# P SERIES LENGTH CHANGE NOTIFICATION

### TAYLORMADE GOLF COMPANY CUSTOM DEPARTMENT NOTICE REGARDING LENGTH MEASUREMENT

## NEW GROUND PLANE MEASUREMENT METHOD

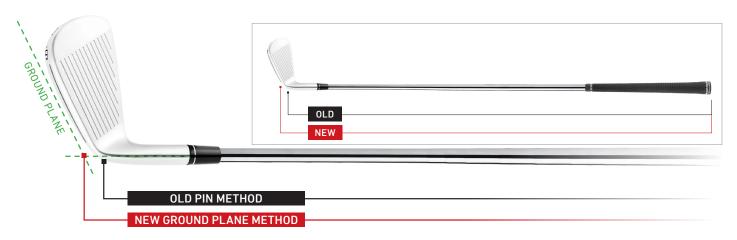
As of 11/1/18, TaylorMade has improved the way we measure and list the overall club length for our iron products. In the past, we measured overall club length using a method referred to as the "pin length." Moving forward, we will be using the measurement method known as "ground plane." The ground plane method is the closest method to an industry standard and is the preferred measurement method of the USGA. Our goal is to simplify the club-length measurement process and improve build accuracy by switching to the preferred USGA ruler. Now matching a customer's existing club length will be easier than ever!

- Our lengths are changing slightly for latest P Series Product (P7TW, P760, P790, P790Ti).
- When compared to the specified club length of previous P•700 series irons the new lengths appear longer, however the physical lengths are slightly shorter (see below).
- Iron lengths are within 1/8" of the previous model (AW is 1/2" different as we want the align the length with the new wedge lengths).
- We have updated our graphite shaft lengths to be the same as the steel shaft builds. This effectively makes graphite shaft club lengths 1/4" shorter than the previous generation.

See below a table for reference. This shows the current and prior P Series iron lengths if they were all measured on the new Ground Plane. As you can see the prior P Series Irons are 1/4" longer or less than the previous generation. (+.5" in the AW).

- · If you were fit for a new iron, perfect! You don't need to do anything except order what you were fit for.
- If you are trying to match the length of a previous P Series set, we would recommend adjusting your club's length by +1/4" to prevent your new irons from coming in shorter than your current build specifications.
